IN THE DRAWINGS

REMARKS

(USSN 10/037,325)

Fig. 7

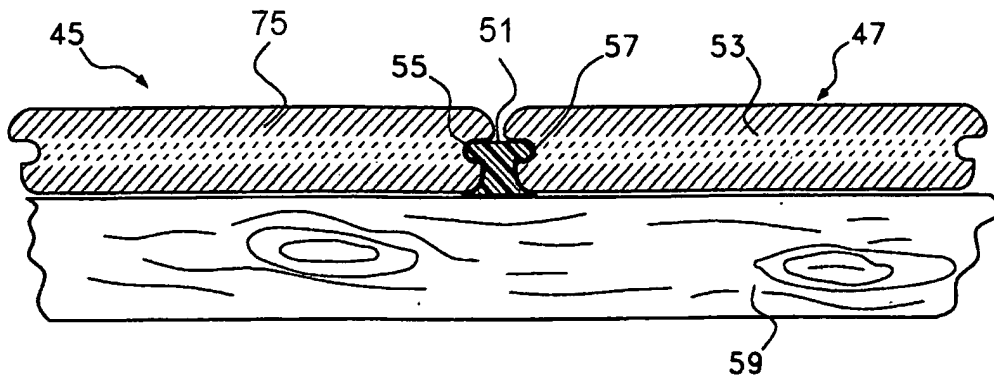
The drawings filed on May 24, 2005, were submitted in response to an objection lodged in the Final Rejection dated December 29, 2004, wherein the Examiner objected to the hatching used for element 51 of Fig. 7 in the version of the drawings submitted on September 12, 2003. In particular, the Examiner stated that the form of

hatching used for element 51 was incorrect for a plastic item. Accordingly, a new drawing sheet 2/2 comprising Fig. 7 was submitted, wherein the hatching of element 51 comported with the form for plastic delineated by the illustration in MPEP 608.02 (IX).

In the present Office Action, the Examiner has raised a different objection, indicating that the use of cross-section hatching may be misleading when compared with the statement in the specification that characterizes Figs. 7 and 8 as “end views.”

A further objection to Fig. 7 was raised, based on the presence of two instances of reference numeral "57." The Examiner has interpreted numeral 57 as referring to both a slot and a horizontal beam. The latter instance is submitted to be an obvious typographical error and has been corrected to be numeral 51. Attention is respectfully drawn to the specification at page 31, line 16 et seq., wherein Fig. 7 is described. Reference numeral 51 is identified at page 32, line 1, as referring to the end view 51 of horizontal beam 45. Reference numeral 57 is identified at page 32, line 9, as referring to a slot of beam 47. It is respectfully submitted that any ambiguity in the duplicate use of number 57 in Fig. 7 is thereby resolved.

For clarity of the record, applicant further notes that in the intermediate version of Fig. 7 submitted September 12, 2003, the anchoring device was erroneously labeled as element "51." The version of Fig. 7 submitted May 24, 2005 restored reference numeral "1" to refer to the anchoring device, in conformity with the labeling given in Fig. 7 as originally filed.

Please replace the two sheets of existing drawings with replacement sheets bearing amended Figures 2 and 7, as well as Figures 1, 3-6, and 8, which are not presently amended. For the sake of clarity, Figure 2 is amended to delete reference numerals 2, 4, and 6; Figure 7 is amended to correct one instance of the reference numeral 57, which should have been reference numeral 75, and the instance of the reference numeral 1, which should have been reference numeral 51.

For the sake of clarity, the specification has been amended in the Brief Description of the Drawings at page to recite Figs. 7 and 8 as being cross-sectional, end views.

In view of the amendment of the description of Figs. 7 and 8 in the specification, the amendment of Fig. 7, and the foregoing remarks, applicant maintains that any ambiguity between the depiction of Figs. 7 and 8 and the description of those figures in the specification, including the Brief Description of the Drawings, has been obviated. The correction of a duplication in use of numeral 57 in Fig. 7 has also been effected.

For reference, a copy of Figure 10 of the British patent, including markings added by the Examiner, is reproduced below.

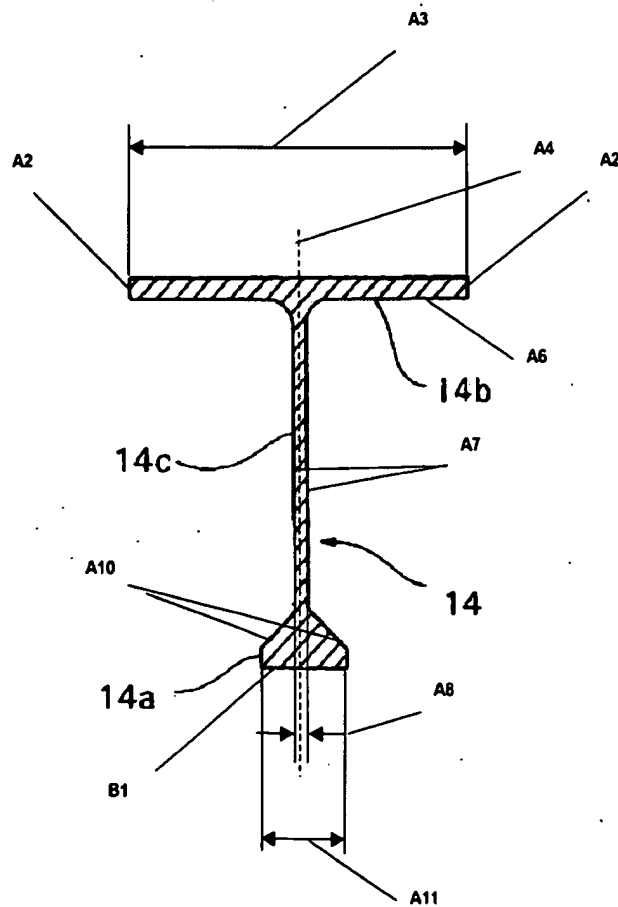
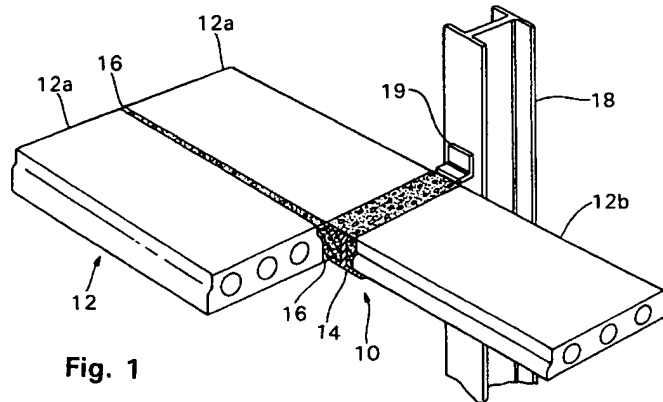
Regarding claim 29, the British patent discloses, in Figure 10, an anchoring device consisting essentially of a substantially flat horizontal top element A10, at least one substantially vertical support member A20, and a substantially flat horizontal bottom element A30. The top element A10 has a top view configuration including two sides A2 and a predetermined first width A3 as measured side to side. The first width A3 is measured at a maximum width between the sides A2. The top element A10 has an imaginary center line A4. The support member A20 is attached to an underside A6 of the top element A10 along the center line A4¹ and the support member A20 extends downwardly therefrom. The support member A20 has two sides A7 and a predetermined second width A8 as measured side to side at a maximum width. The bottom element A30 has a flat bottom view configuration, which includes sides A31 and having a generally trapezoidal shape, and a predetermined third width A11 as measured side to side at a maximum width at a trapezoidal base B1. The first width A3 is greater than the second width A8 and the third width A11. The third width A11 is greater than the second width A8. The device is made of molded plastic material (column 4, lines 72-84).

feature corresponding to the receiving slots delineated by claims 29 and 33. Page 2, col. 1, lines 11-13 and 40-43. Horizontal projections A2 of “top element” A10 are not received in any slot. Instead, element A10 is installed with its horizontal projection A2 underneath the back surface of each tile, and with the plain edge of each tile abutting sections A7 and A31 on each side of grouting strip 19.

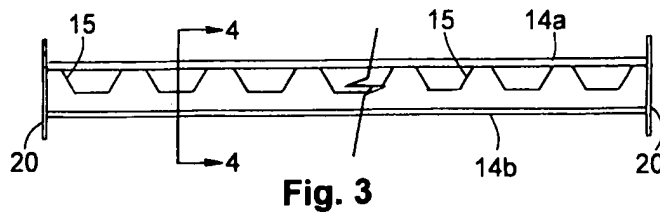
The present Office Action refers to the marked-up version of Fig. 3 of Fisher et al. included in a previous Office Action. Significantly, that version of Fig. 3 is depicted in an orientation that has been inverted with respect to Fig. 3 as it was originally presented in Fisher et al. The original orientation of Fig. 3 places the largest width of beam 14 (denoted as A3 by the Examiner) on the bottom, corresponding to its disposition in the finished construction shown in Figs. 1 and 2. By way of contrast, and without notice, the Examiner has placed the largest width (i.e. the width of flange 14b) on the top of the altered drawing. Applicant maintains that "top" and "bottom" as used in both Fisher et al. and the instant specification are terms of ordinary language. They have not been imbued with any special technical meaning by applicant or by any of the prior art references applied, including Fisher et al. It is submitted that the Examiner's alteration is repugnant to ordinary meaning and thus impermissible, absent clear evidence to substantiate the change. The distinction between "top" and "bottom" is not a matter of mere semantics, because the "bottom" of Fisher et al.'s dissymmetric structural steel beam 14 is defined by the direction of gravity and the beam's function of supporting planks 12a, 12b. Clearly, the inversion of beam 14 in an actual building structure employing the construction depicted by Figs. 1 and 2 of Fisher et al. would have disastrous consequences. Were the Fisher et al. beam installed in the inverted position, it inherently could not support the concrete planks, which would have to rest

on an angled surface of the trapezoidal “bottom,” not on a flat surface. Clearly, no skilled artisan would contemplate such a configuration. The Fisher et al. reference does not disclose or suggest any function for dissymmetric structural steel beam 14 used in the inverted position implied by the Examiner’s recasting of Fig. 3.

(Chen et al., US Patent 6,363,677, as annotated by the Examiner)

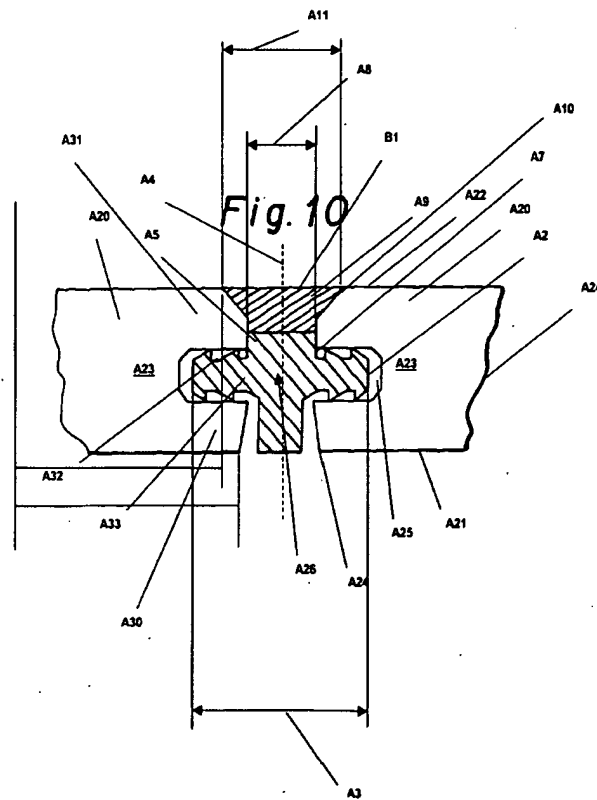
Regarding claim 33, Chen discloses in Figure 5², a decking system comprising boards A20 and an anchoring device A26. Each of the boards A20 has a top A21, a bottom A22, two sides A23 and two ends A24. At least one groove A25 is located along one of the sides A23. The anchoring device A26 consists essentially of a substantially flat horizontal top element A1,³ at least one substantially vertical support member A5, and a substantially flat horizontal bottom element A9. The top element A1 has a top view configuration including two sides A2 and a predetermined first width A3 as measured side to side. The first width A3 is measured at a maximum width between the sides A2. The top element A1 has an imaginary center line A4. The support member A5 is attached to an underside A6 of the top element A1 along the center line A4 and the support member A5 extends downwardly therefrom. The support member A5 has two sides A7 and a predetermined second width A8 as measured side to side at a maximum width. The bottom element A9 has a flat bottom view configuration, which includes sides A10, and having a generally trapezoidal shape, and a predetermined third width A11 as measured side to side at a maximum width at a trapezoidal base B1. The first width A3 is greater than the second width A8 and the third width A11. The third width A11 is greater than the second width A8. The device is made of molded plastic material capable of having a metal fastener driven through (col. 7, lines 56-60).

The confusion arising from the Examiner’s inversion of the supposed Chen anchoring device is even further compounded by the Examiner’s characterization of the sides A2 as defining a width A3 of what he purports to be the top element A1 [*sic*]. On the other hand, claim 33 calls for an anchoring device having a “substantially

With respect to claim 33, it is submitted that Chen et al. discloses a portion of element 54 extending downward from the projections received in board grooves A25 in the depiction of annotated Fig. 10 (the “top” of the Chen et al. structure

as apparently understood by the Examiner⁵). The presence of such a portion establishes a surface of element "A1" that is not substantially flat horizontally. This non-flat surface takes the cited structure outside the scope of claims 29 and 33, the downwardly extending portion being excluded by the language of claims 29 and 33. Applicant thus maintains that the purported anticipation of claim 33 by any structure disclosed by Chen et al. is precluded.
